METROPOLITAN GOVERNMENT OF NASHVILLE AND DAVIDSON COUNTY

STAFF RECOMMENDATION 4709 Elkins Avenue December 16, 2020

Application: New Construction—Infill
District: Park and Elkins Neighborhood Conservation Zoning Overlay
Council District: 24
Base Zoning: RS7.5
Map and Parcel Number: 09115034400
Applicant: Tarl LaRocco
Project Lead: Melissa Sajid, Melissa.sajid@nashville.gov

Description of Project: Application is to construct one and one-half story infill.

4709 ELKINS AVENUE
SITE PLAN • SCALE: 1"=20'

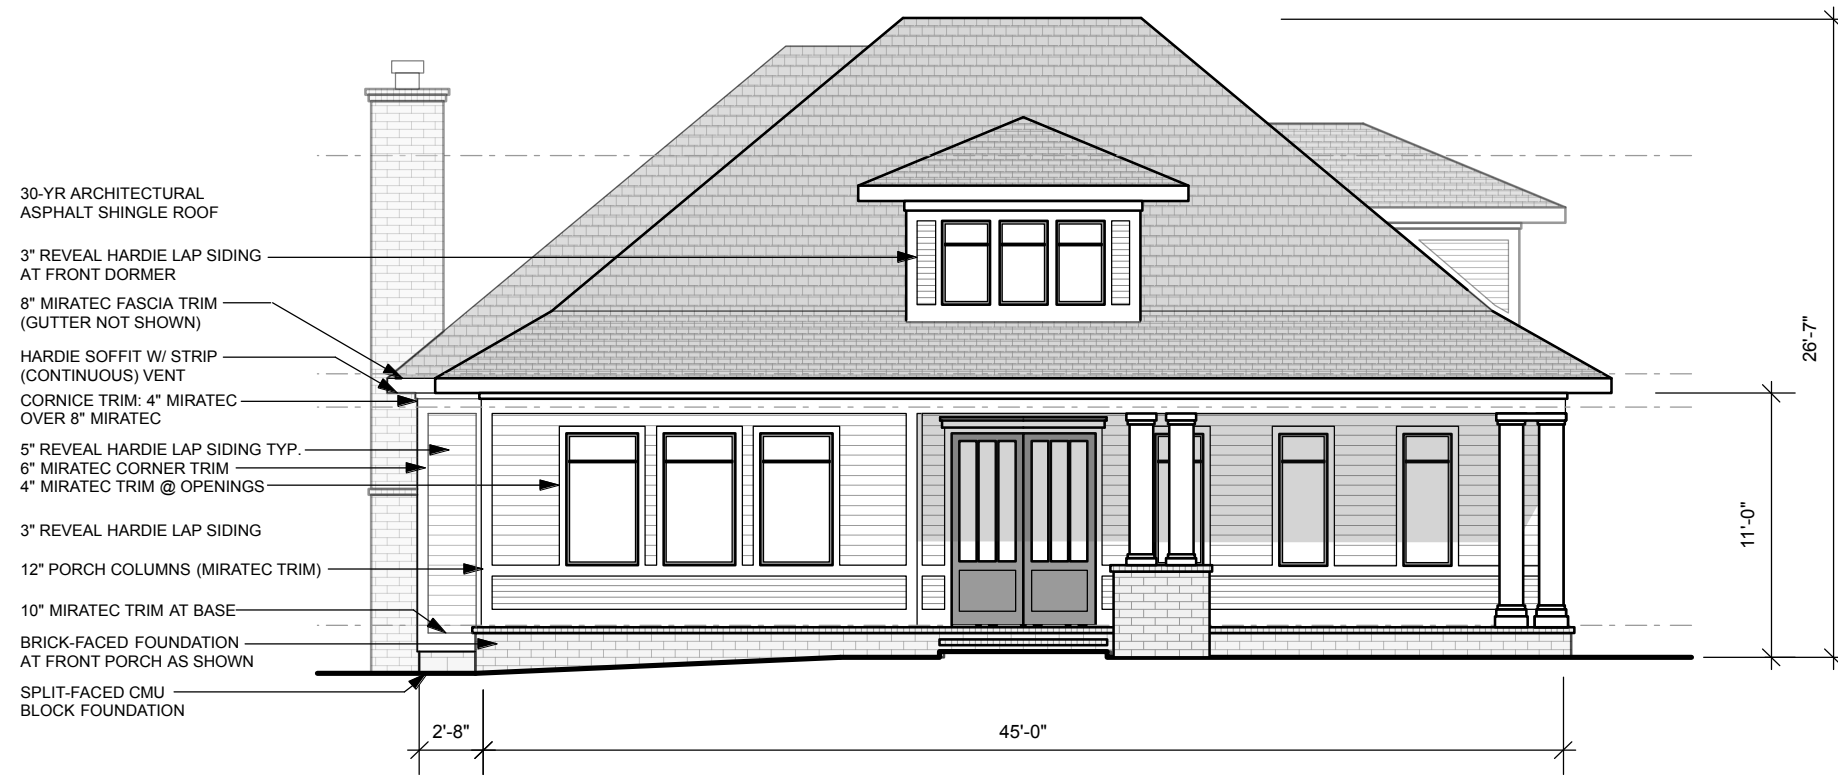
Setback & Rhythm of Spacing: The front setback is thirty-four feet (34') which is appropriate as it between the front setbacks established by the historic houses at 4707 and 4711 Elkins Avenue. The infill is located eleven feet, four inches (11'-4") from the right-side property line, eleven feet (11') from the left, and fifty-six feet (56') from the rear property line. The project meets all base zoning setbacks and the setback and rhythm of spacing are appropriate for the historic context.

Orientation: The infill is oriented to Elkins Avenue. Staff recommends that a walkway connecting the front porch to the public street be added to the site plan before the preservation permit is issued.

4. Staff approve a masonry sample prior to purchase and installation;
5. A walkway connecting the front porch to the public street shall be added to the site plan;
